# Architect's Supplemental Instructions

Police Department Midtown District

ASI Number 004

1/25/2018

**FIRST FLOOR  
FRAMING PLAN**

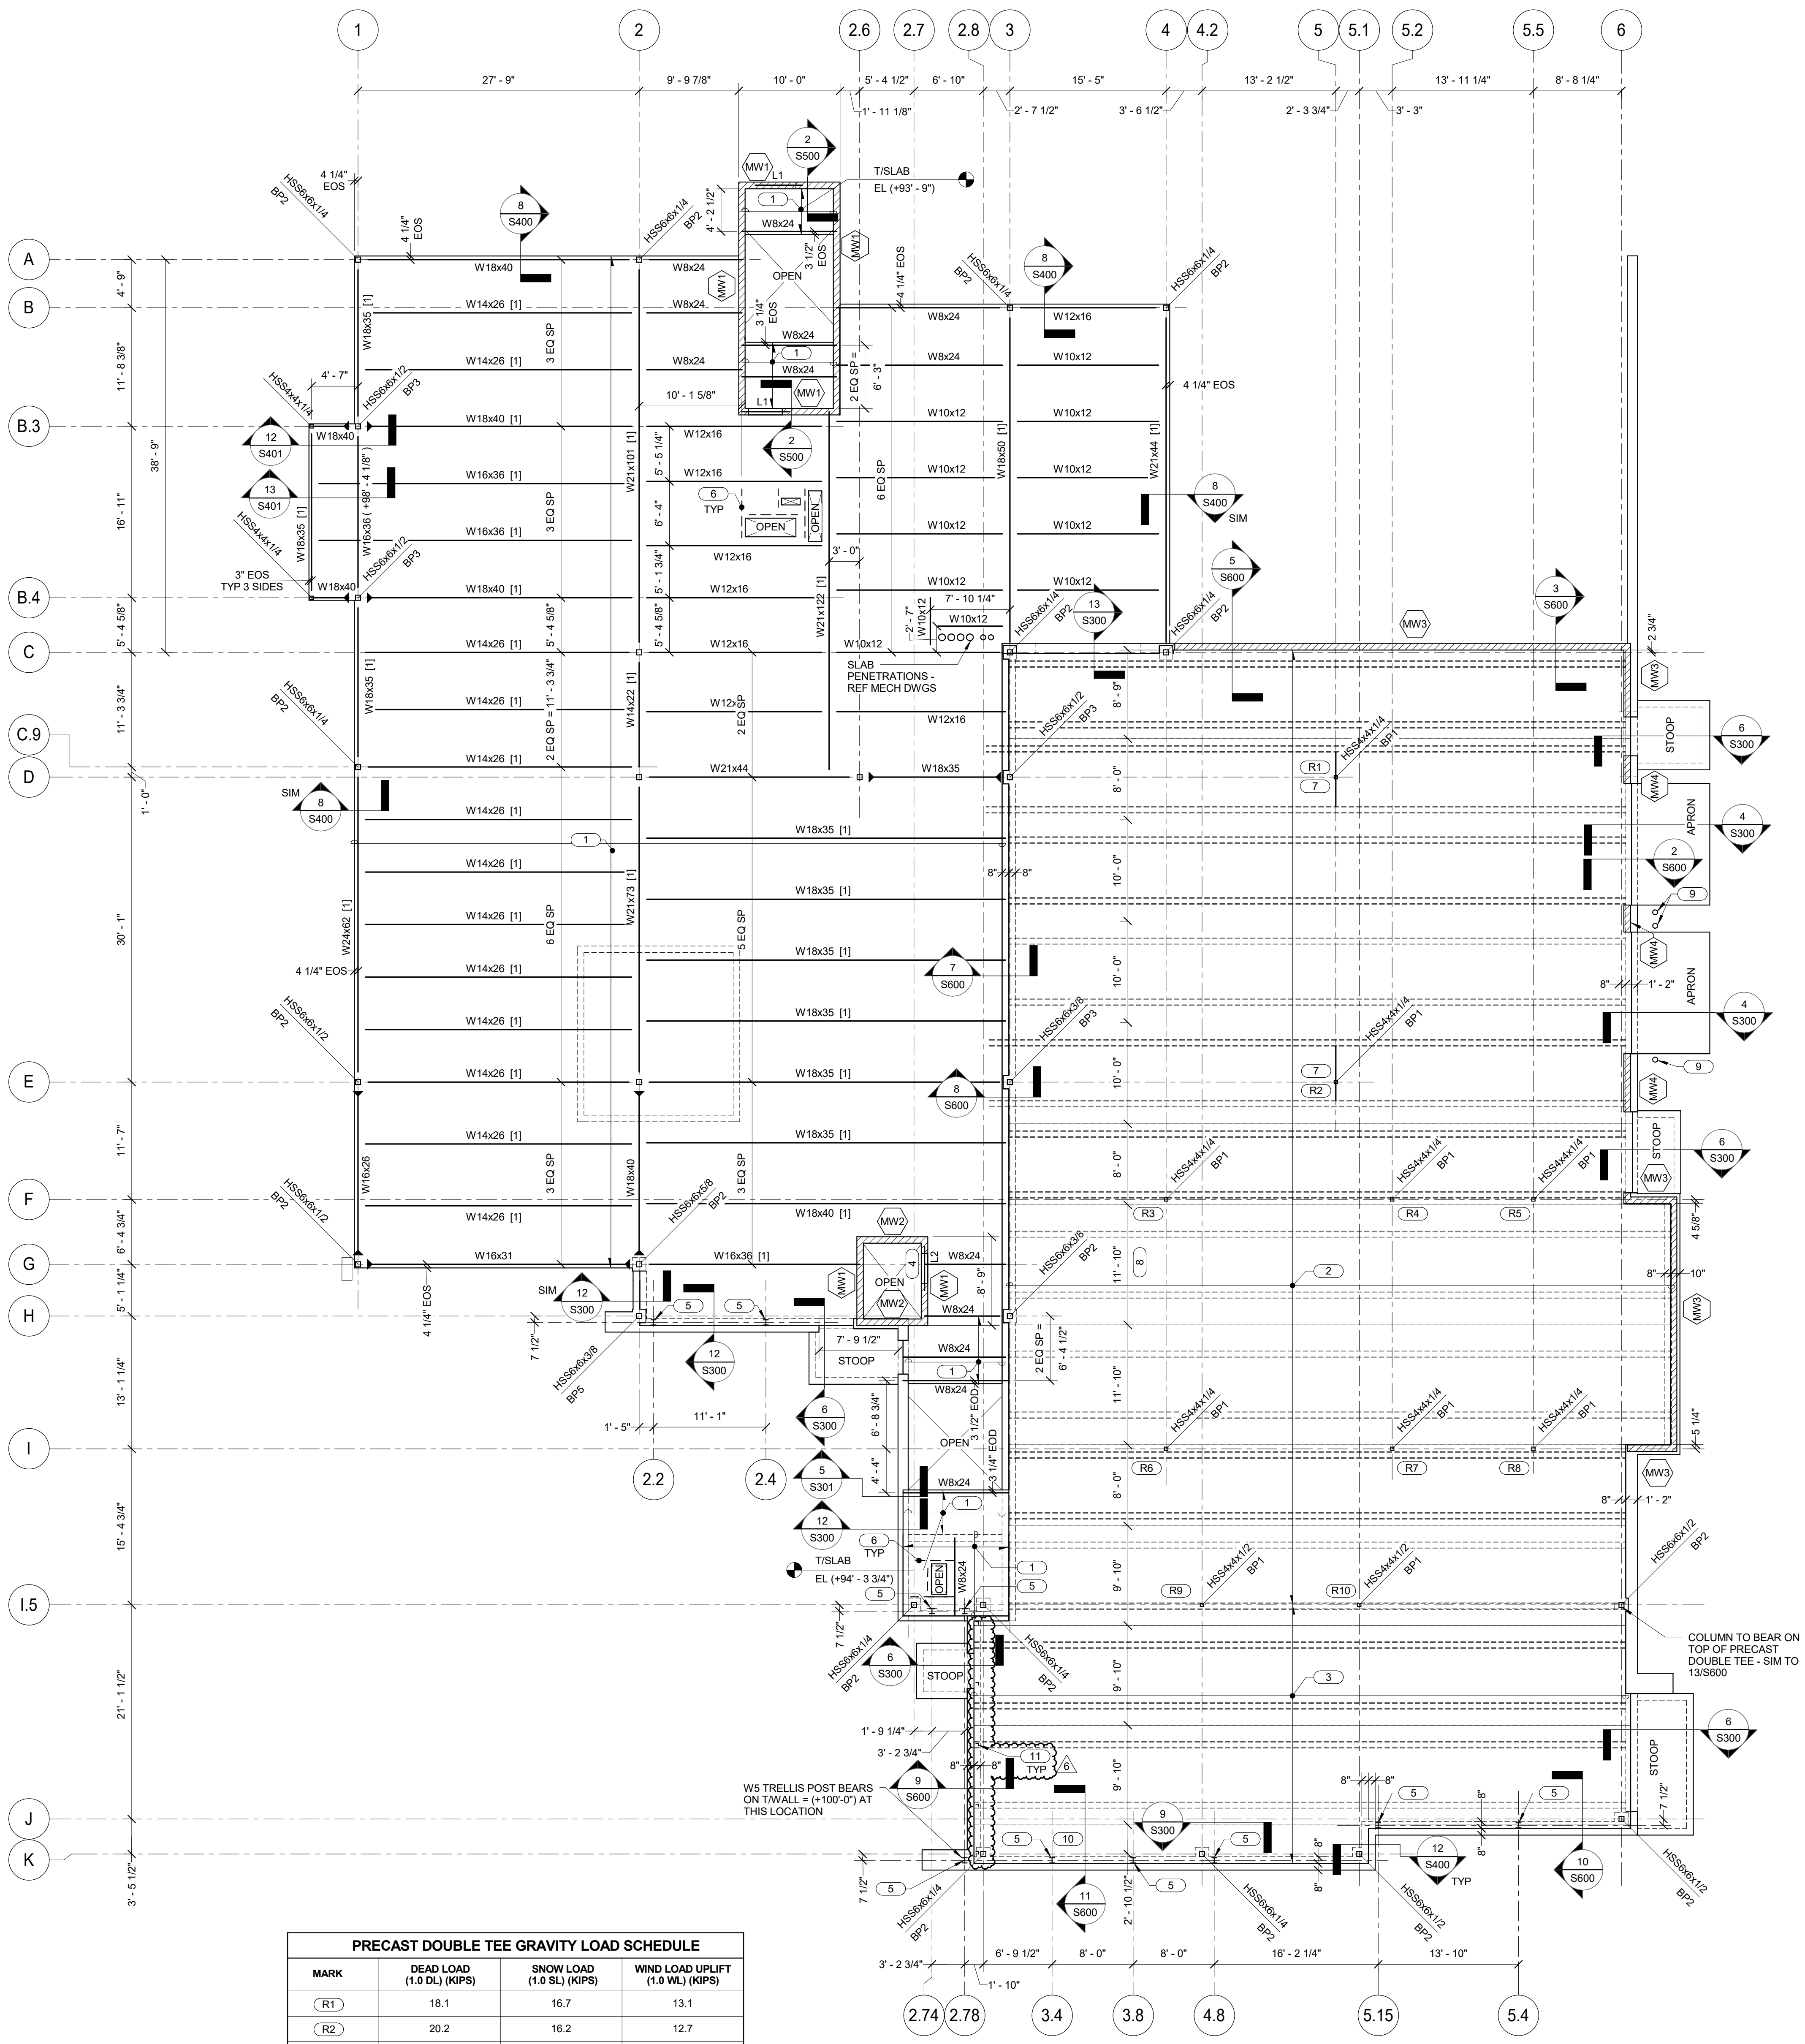
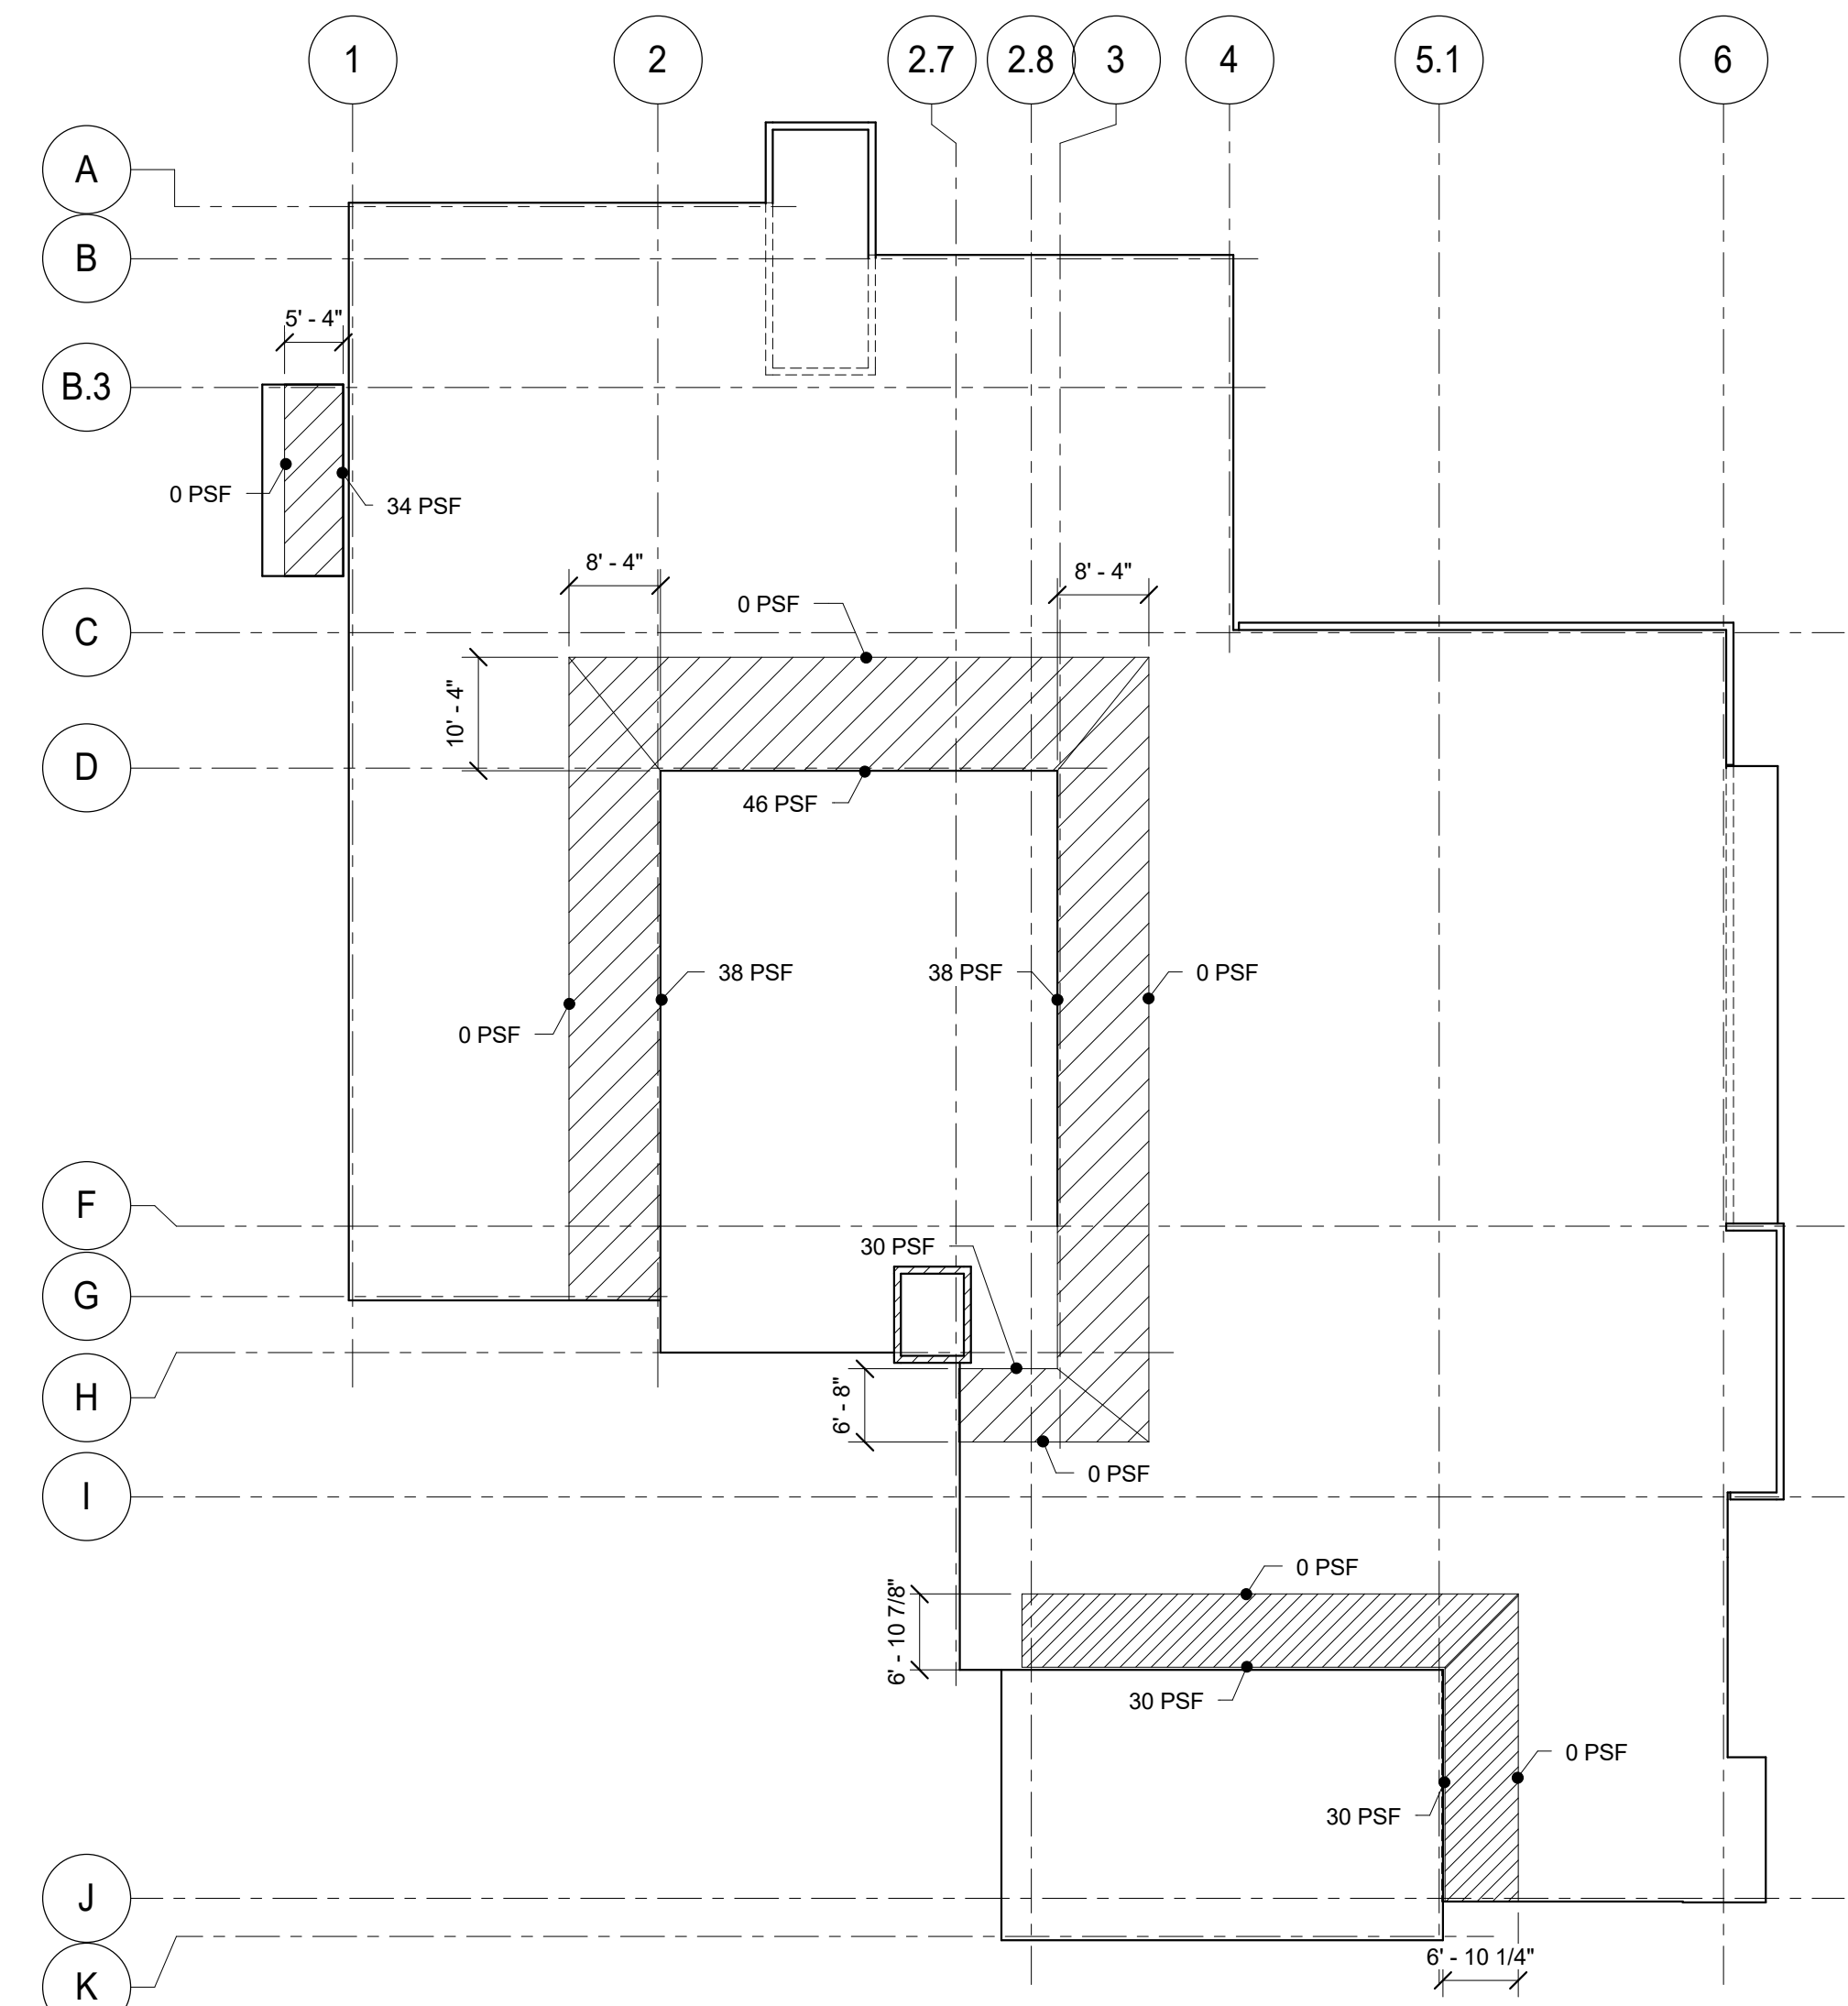
4. The attached sheet S101 has been issued with the following revisions:
  - A. ADD L3x3 vertical angles in the stud wall cavity below Storefront M to provide support for metal stud framing as addressed in RFI 020.

- PIPE BOLLARD. COORDINATE ALL LOCATIONS WITH ARCHITECTURAL DRAWINGS. REFER TO 6/S600.
  - 12" PRECAST PLANK.
  - BELOW SILL OF STOREFRONT. INSTALL 1.38x1/4" x 2'-0" LONG VERTICAL ANGLES CENTERED IN STUD WALL, EMBEDDED 4" INTO TOPPING SLAB @ 6'-0". COORDINATE LOCATION WITH LIGHT GAGE STUD SUPPLIER.
